CHANGES FROM BASE PRODUCT VBV-L4025 (1554) TO AC-044 (4279)

1	Approved by G.PUTH	Checked by B.CHILDS	Drawn by M.POTTER
	Units	Scale	Released
	mm	N/A	13/06/13
	Assembly Ref -		
Status RELEASED	AC-044

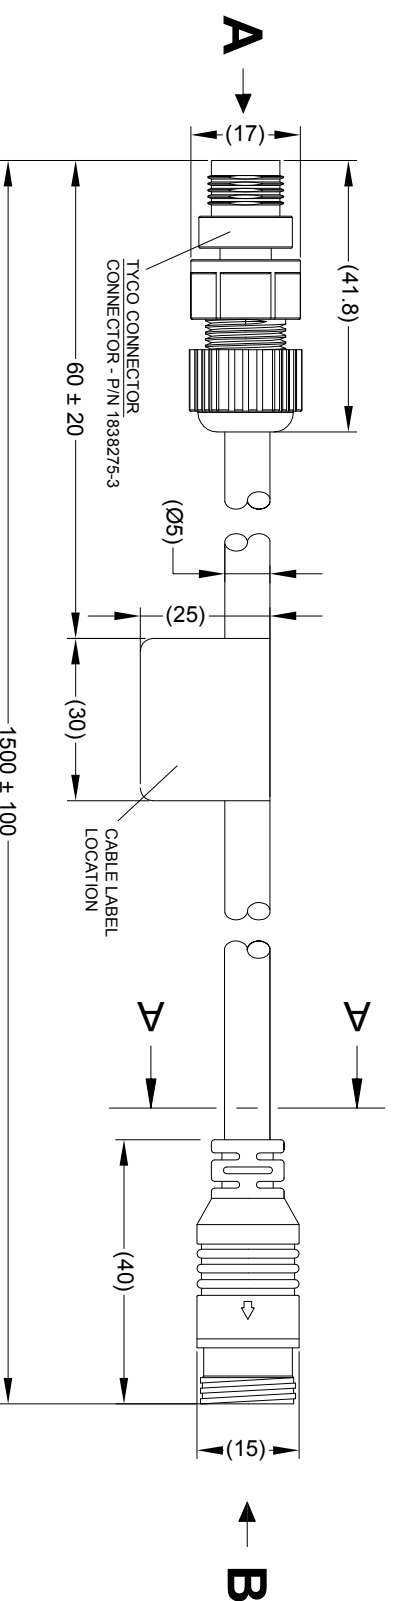
1. CUT CABLE TO REQUIRED LENGTH.
2. REPLACE 4 PIN FEMALE CONNECTOR WITH 5 PIN MALE M12 CONNECTOR.
3. REPLACE VBV-14025 CBL-LBL WITH AC-044 (4279) CBL-LBL.
4. REPLACE VBV-14025 GB-LBL WITH AC-044 (4279) GB-LBL
5. REMOVED PROTECTIVE BOOT.
